Drawing Title			
Proposed Elevations Unit 3			
Scale:	Date:	Drawn:	Checked:
1:50 @ A1	Dec 2019	Craig Harrison

5766 - T06G

Proposed Dwellings
Land at Victoria Terrace
Mellor Brook

Side 2 Elevation (North)
1:50 Scale

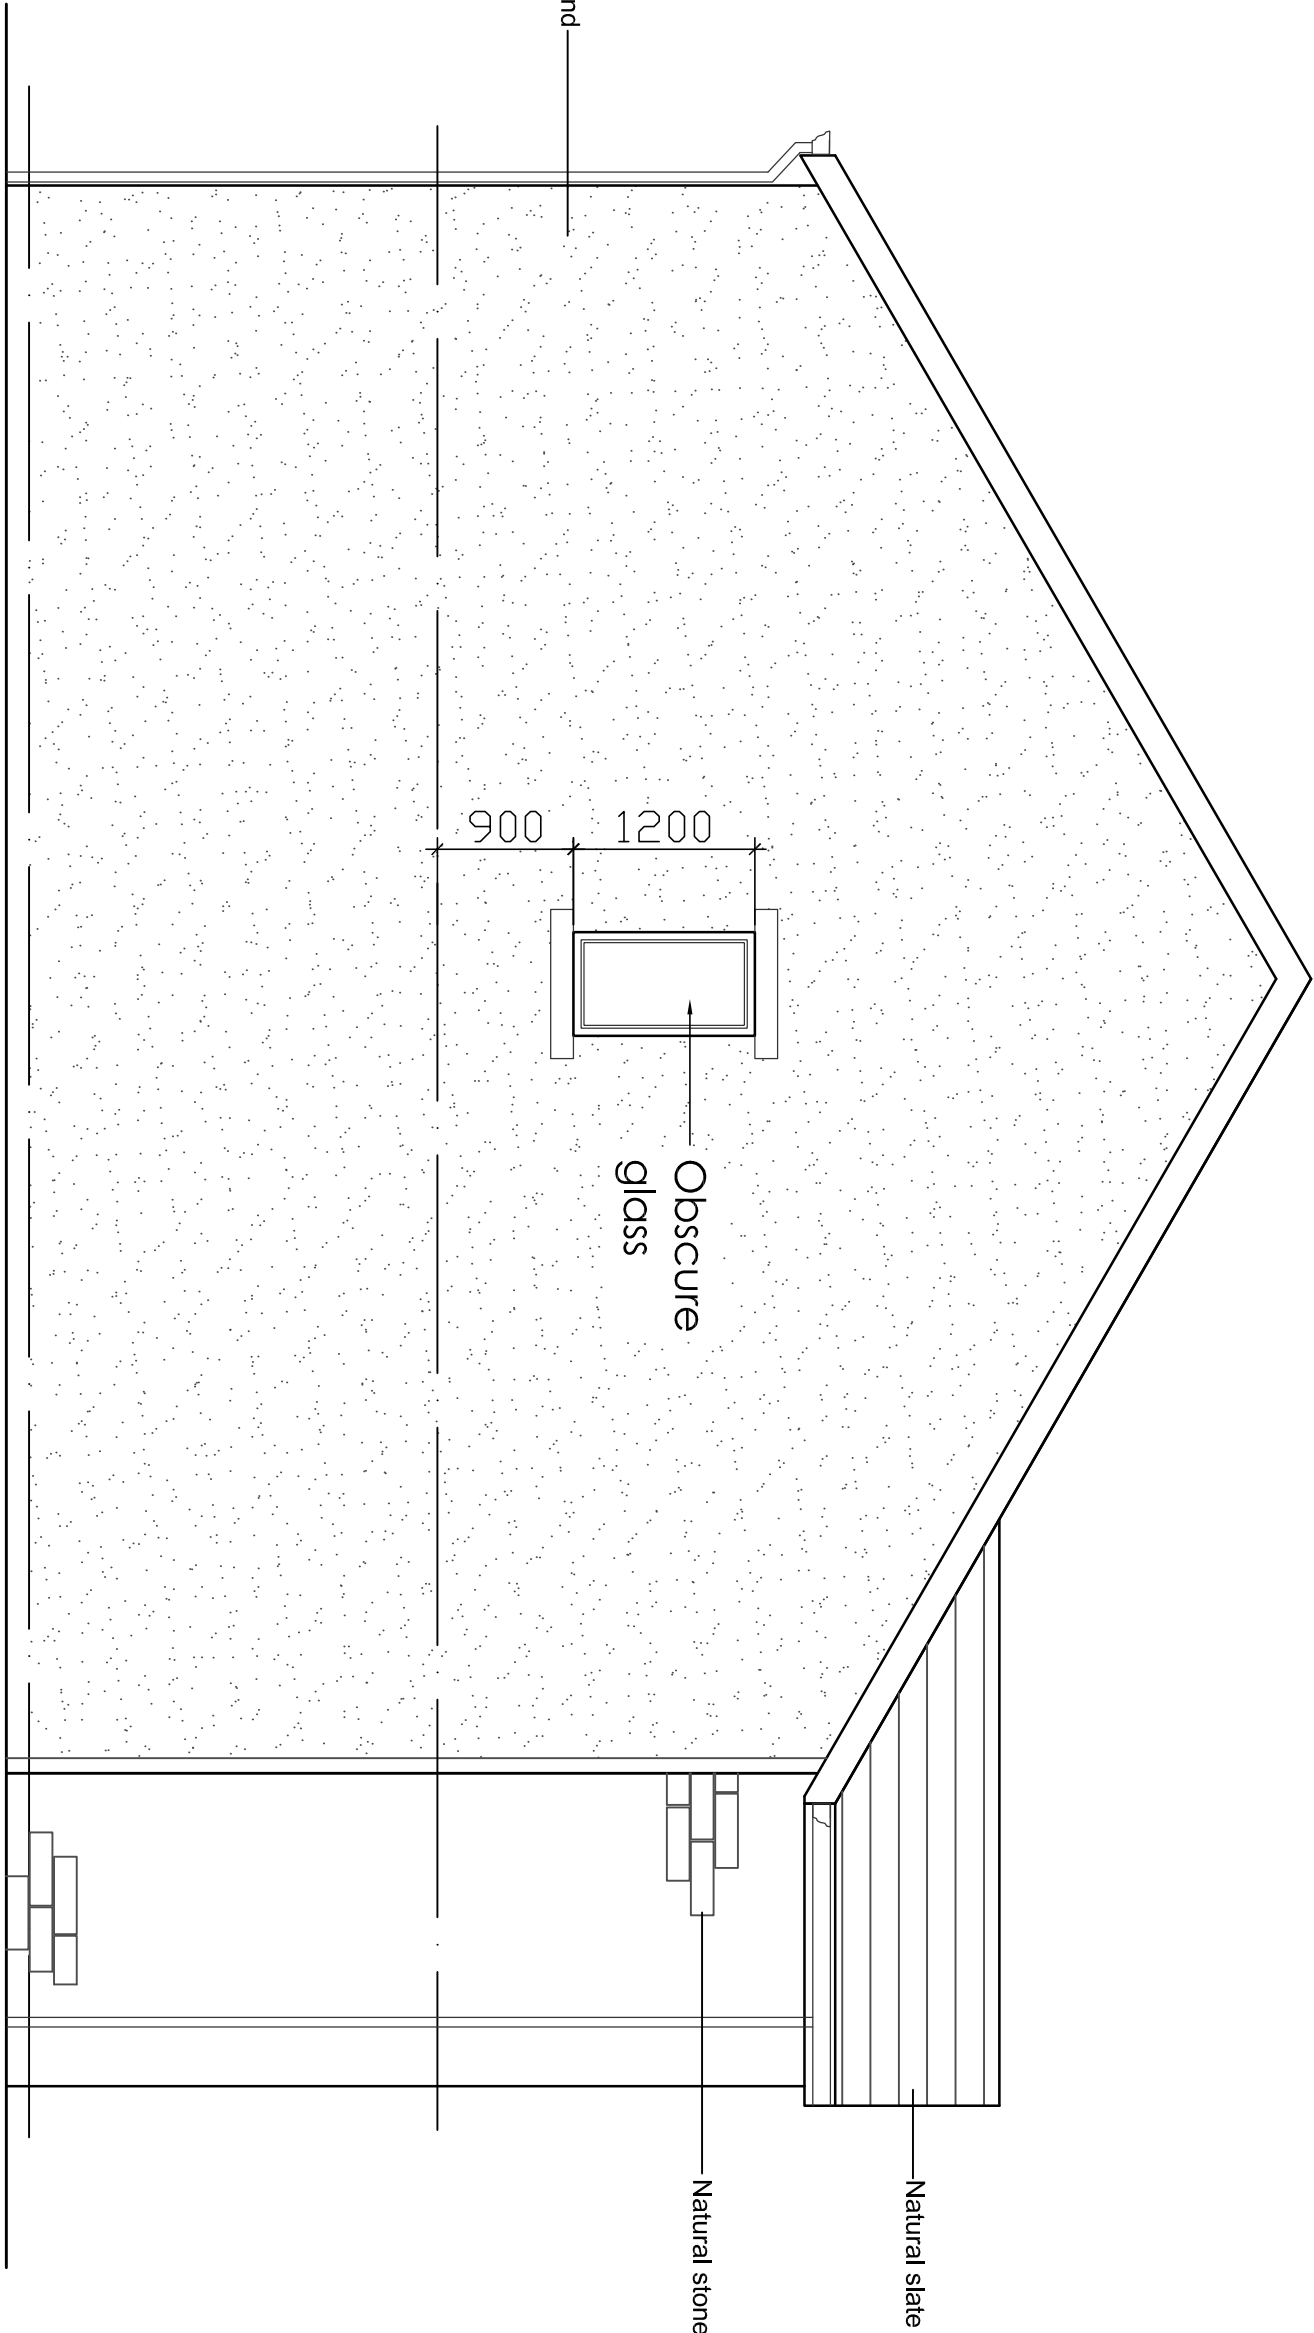
Rev G: Change window over Garage to 3 pane, as requested by RVBC, 29.07.2021
Rev F: First Floor extension proposed over garage - Variation of condition application, 14.05.2021
Rev E: First floor extension omit from over garage, materials changed to stone to front elevation with K-Rend to sides and rear, 13.05.2021
Rev C: Client alterations as per marked up sketches, 18.05.2021
